## DEVELOPMENT APPLICATION ASSESSMENT REPORT

<b>Application Number:</b>	DA2021/0010
----------------------------	-------------

<b>Responsible Officer:</b>	Alex Keller
<b>Land to be developed (Address):</b>	Lot 5 DP 6000, 10 Gardere Avenue CURL CURL NSW 2096
<b>Proposed Development:</b>	Demolition works and construction of dwelling house
<b>Zoning:</b>	Warringah LEP2011 - Land zoned R2 Low Density Residential
<b>Development Permissible:</b>	Yes
<b>Existing Use Rights:</b>	No
<b>Consent Authority:</b>	Northern Beaches Council
<b>Land and Environment Court Action:</b>	No
<b>Owner:</b>	Paul Andrew Torrington Annette Torrington
<b>Applicant:</b>	Harmony Creative Pty Ltd T/A Urban Harmony

Figure 3: Upper storey comparison and front setback line comparison for the proposal.

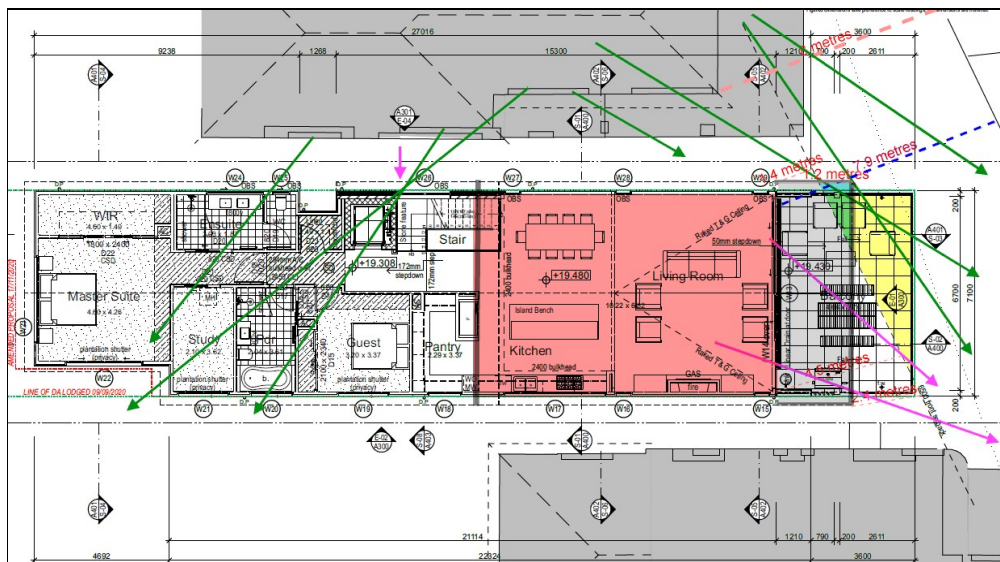
Views are obtained from the upper level whereby the higher topography and side windows assist views lines from No.12 Gardere Avenue. These are across the side boundary as shown below in Figure 2 and 3 (green lines). Views from a sitting and standing position are currently possible from the front and central rooms within the dwelling No.12 Gardere Avenue and from external balcony areas. In general, views are not significantly obscured from the front balcony (north facing) however this balcony has a side area (eastern side) that will be affected by the proposed dwelling at No.10 Gardere Avenue.

Views across the centre rear are able to be maintained from a standing position only by the use of a low pitched roof over the bedroom areas with minimal floor to ceiling heights being used. This view is across a view corridor that crosses other side setbacks and rear setbacks (as indicated in Figure 2). This however creates design issues for services such as air conditioning that require adequate roof space for ducting. Additional wall space at the rear of the gable roof space has been considered and the principal standing views are retained.

Toward the front of the site sitting and standing views are blocked along a narrow corridor across the side boundary. This is partly due to the variation in site levels, requirement for the building to be in a forward position due to the stormwater / overland flow path at the rear and desire to also access the same view line along Gardere Street. In consideration of this the angle boundary creates a staggered (sawtooth) arrangement along the front setback for the southern side of Gardere Street and therefore elements such as front balconies, garages, and other built forms impact on the particular view angles toward the east and north east.

Figure 4: Roof area shows view sharing impacts at rear (standing) and front (standing and sitting) partly obscured by the roof.

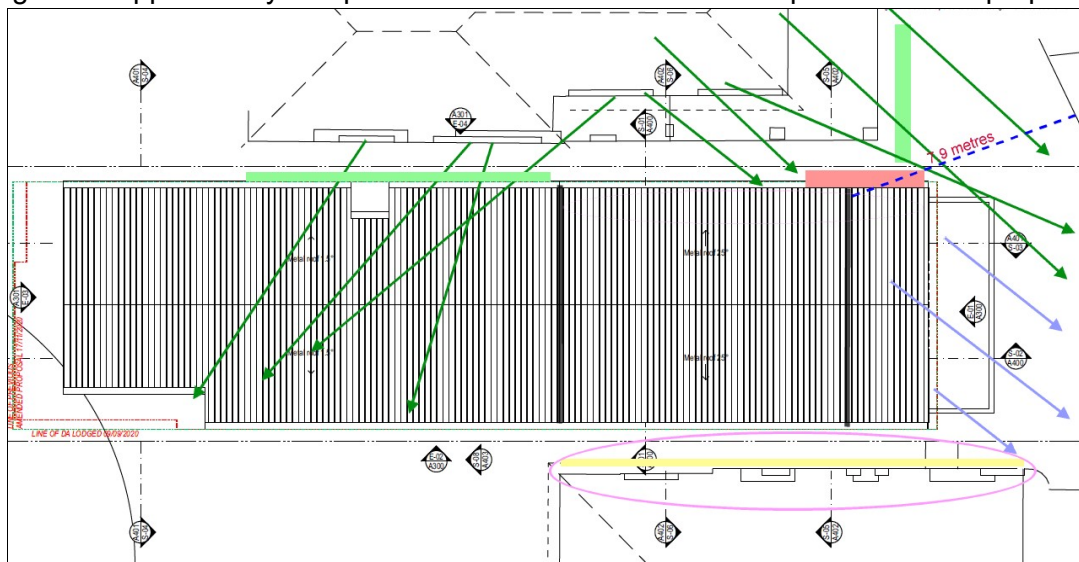
It is noted that setbacks are normally measured to the vertical elements of the building (wall, windows, pillars) which allows for standard width eaves being acceptable encroachments. Currently the front post further forward and does not comply in the NW corner with compliance requiring in the order of 0.75m change to align with the 6.5m building line (and considering a regular 0.225 overhang from the corner post). In this regard, it is possible to moderate the impact by conditions to ensure the hood overhang complies with the front setback. In doing so, the amenity and design appearance can be maintained by "sharing" the setback adjustment by marginally reducing the internal depth of the living kitchen room with the front balcony area, to

achieve a more skilful design solution that achieves a compliant roof setback.

Figure 8: View from front balcony of No.12 Gardere Avenue with survey / RL's overlaid.

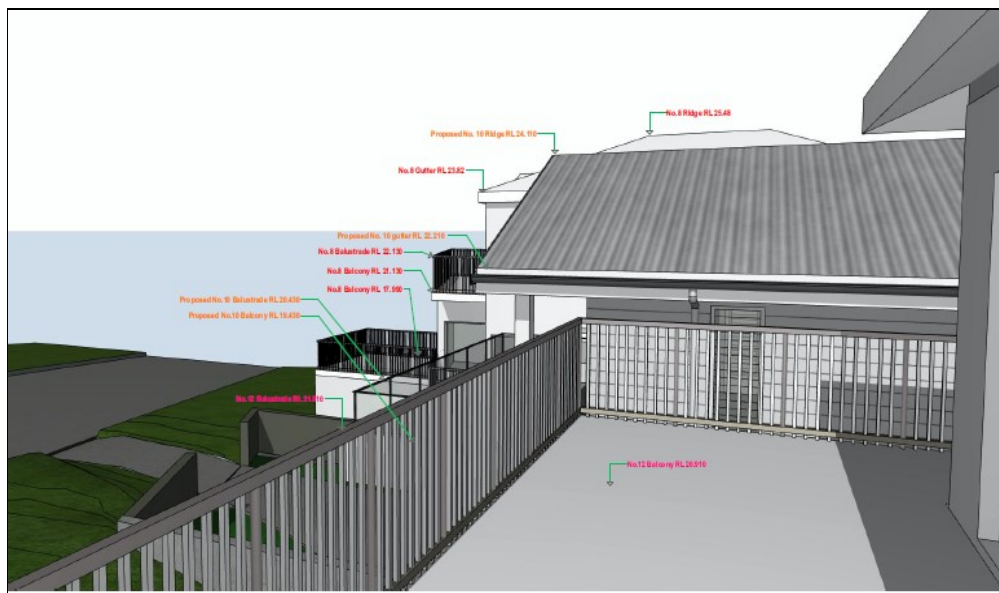
In summary, the front living room corner side window for No.12 Gardere Avenue and the viewing angle (being visibility of the ocean) is partly hindered by No.8 Gardere Avenue and other existing development on northern side of Gardere Street. The broader view from the front part of the living room and adjacent the balcony sliding door is substantially retained if the roof eave is marginally altered to be along the 6.5m setback line due to the lower NE corner of the front balcony gable roof. Toward the front (northern side) of the balcony for No.12 Gardere Avenue the view line is substantially retained as indicated in Figure 8 below.
